May 2, 2019

Technical Service Bulletin Gunite Brand Automatic Slack Adjusters - Roll Pin Protrusion Subject PNs: All Automatic Slack Adjusters assemblies

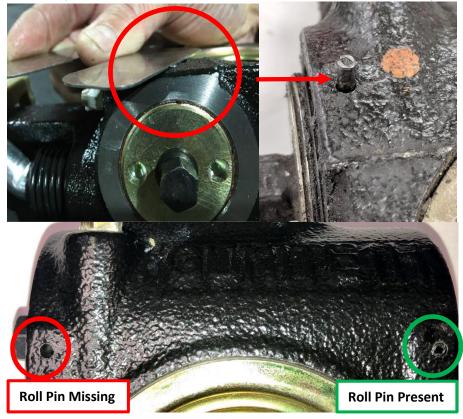
All warrantied ASAs manufactured from December 1, 2016 to November 26, 2018 with old roll pin design. ASAs manufactured after November 26, 2018 have the new roll pin design shown in the image below and are not affected.

The check can be performed by a technician using a 0.060" (1.5mm) measurement device such as a scale, shim, or feeler gage. If the roll pin is missing or protruding by more than .060", replace the ASA and follow the instructions in the Warranty Claim Form link below to return the ASA to Accuride for warranty replacement. The warranty claim form can be found online at:
